SOUTH WEBER CITY PLANNING COMMISSION AMENDED AGENDA

PUBLIC NOTICE is hereby given that the **Planning Commission of SOUTH WEBER CITY**, Utah, will meet in a **REGULAR** public meeting on **Thursday, October 11, 2018** at the **South Weber City Council Chambers, 1600 East South Weber Drive**, commencing at **6:30 p.m.**

CONDITIONAL USE REVIEW

TWO-FAMILY DWELLING @ MAJOR INTERSECTION:

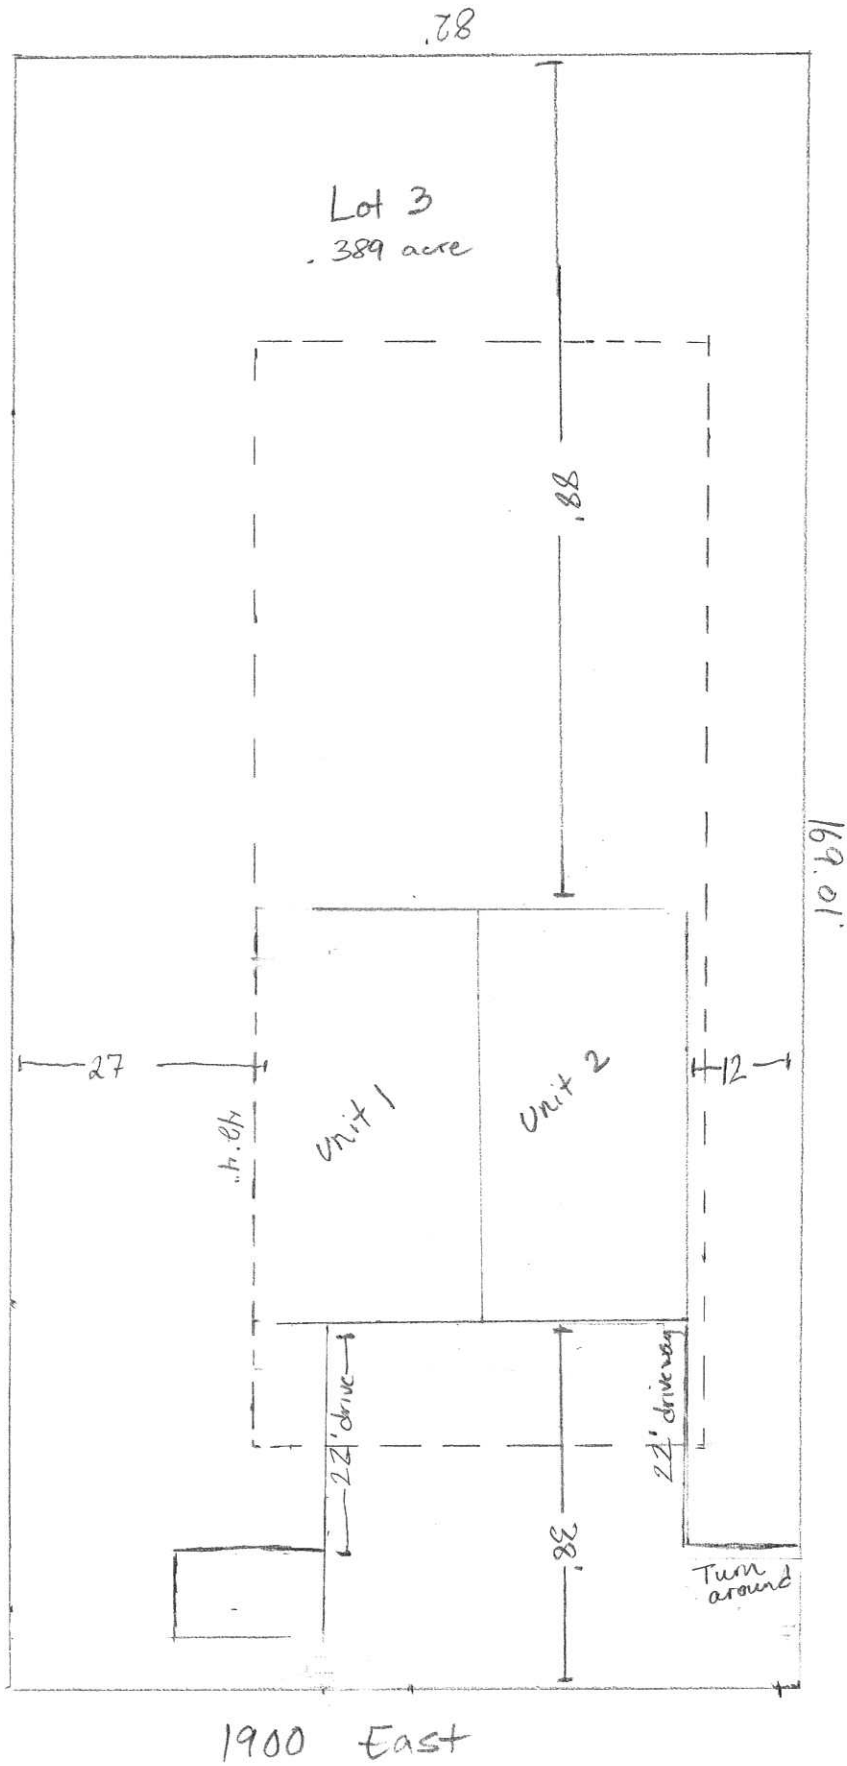
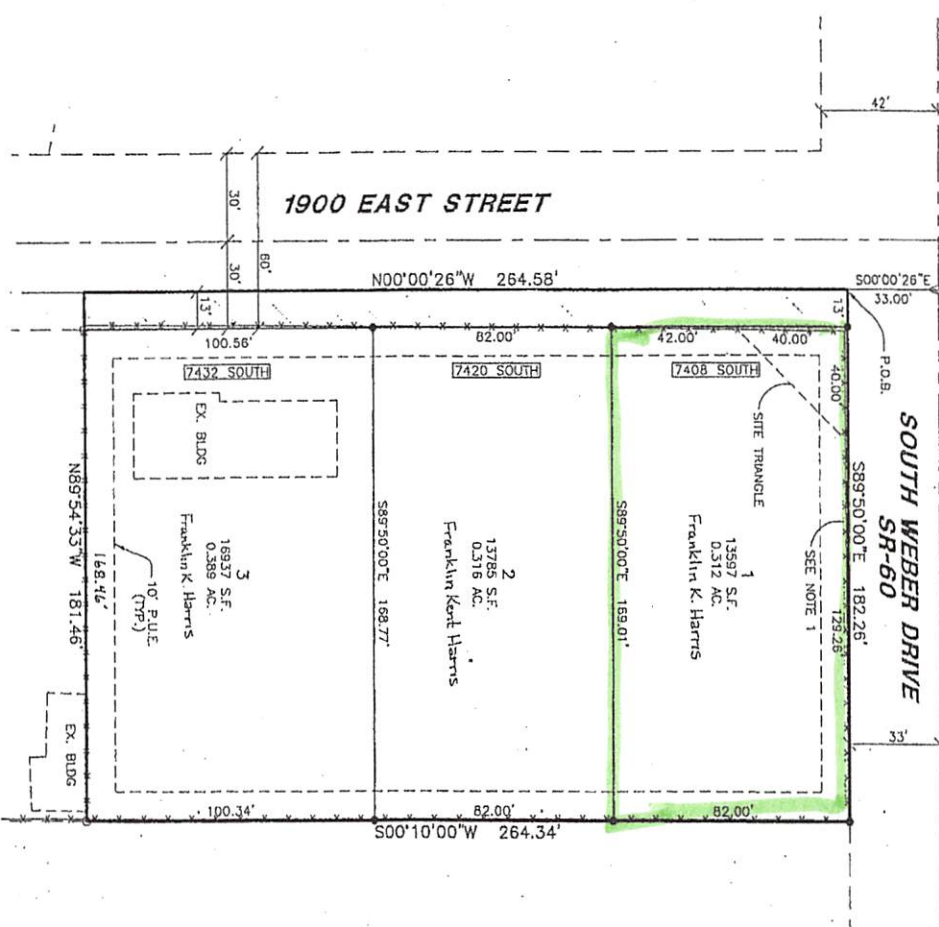
Ordinance Compliance: This proposal is at the intersection of South Weber Drive and 1900 East, one of the intersections where a two family dwelling is allowed as a conditional use. The site plan needs to be approved by the Planning Commission, but the submitted plan is very sketchy and lacks enough detail to determine if it is adequate. We need a drawing showing all dimensions of the dwelling, driveway and turn around areas, curb, gutter and sidewalks on both streets, existing utility equipment, landscaped areas and any other pertinent details.

Recommendation: I recommend tabling this item until such time as a complete site plan has been submitted.

Project Info.	
Engineer:	N. Reeve
Designer:	C. Cave
Begin Date:	August 28, 2017
Name:	HARVEST PARK SUBDIVISION
Number:	1301-025

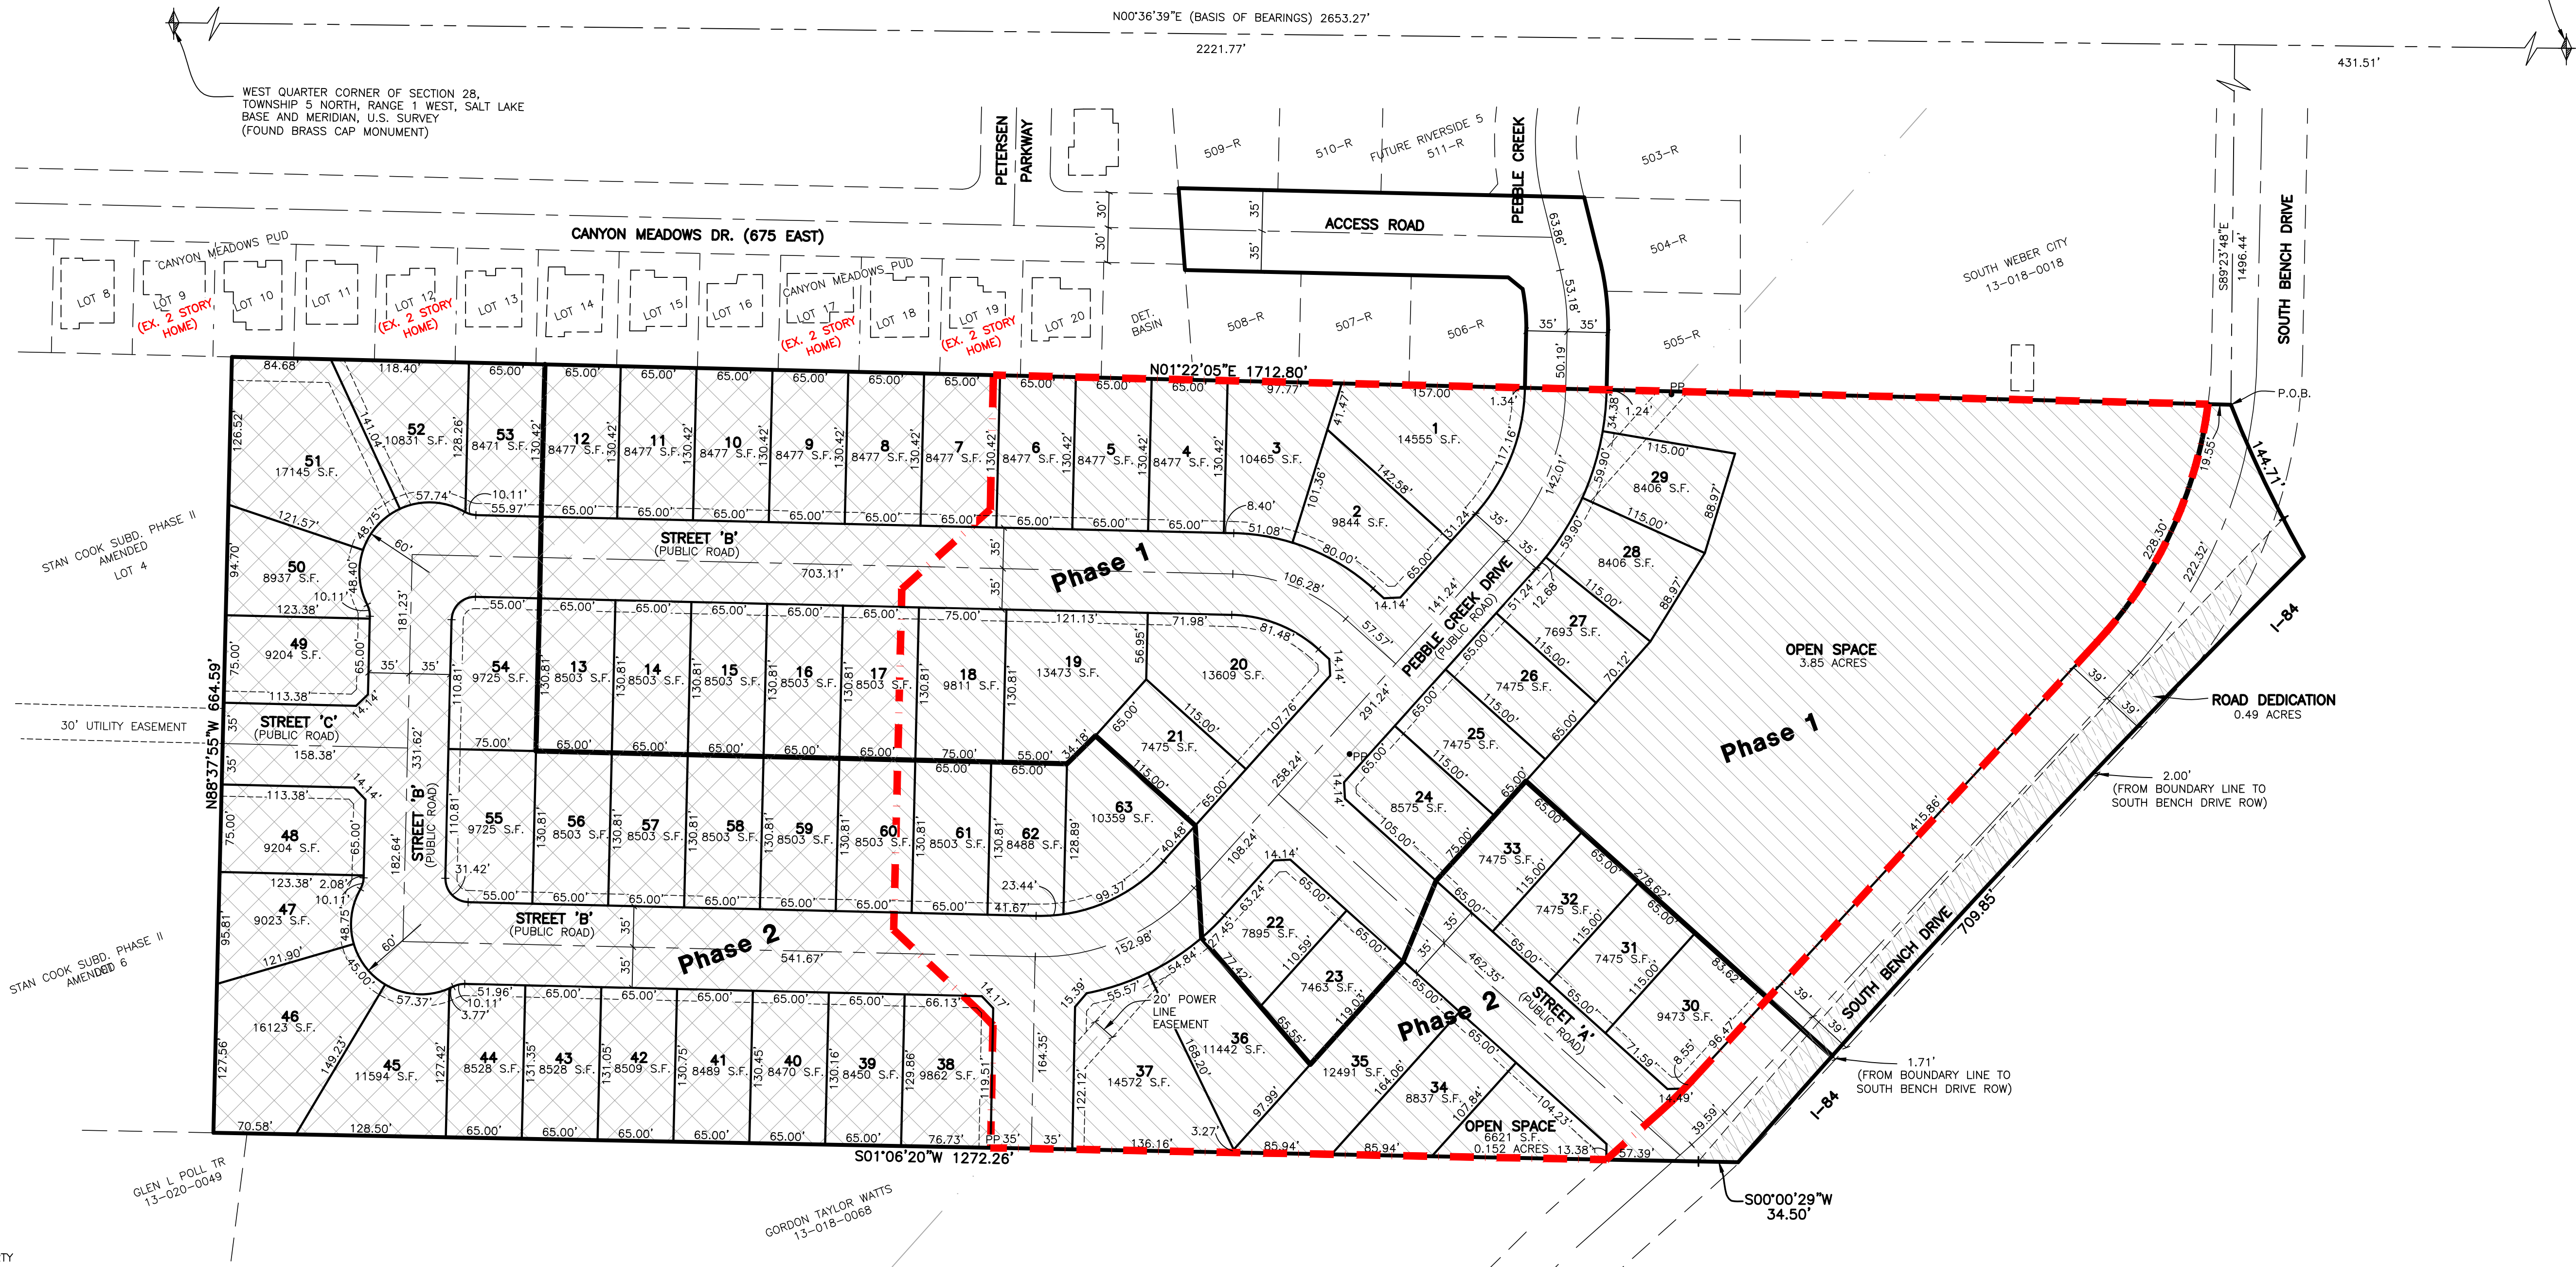
50%, 17 LOTS (MAX. HEIGHT): 35 FEET

LOTS 6-12 & 51-53 SPECIFICALLY RESTRICTED, 10 LOTS (MAX. HEIGHT): 25 FEET
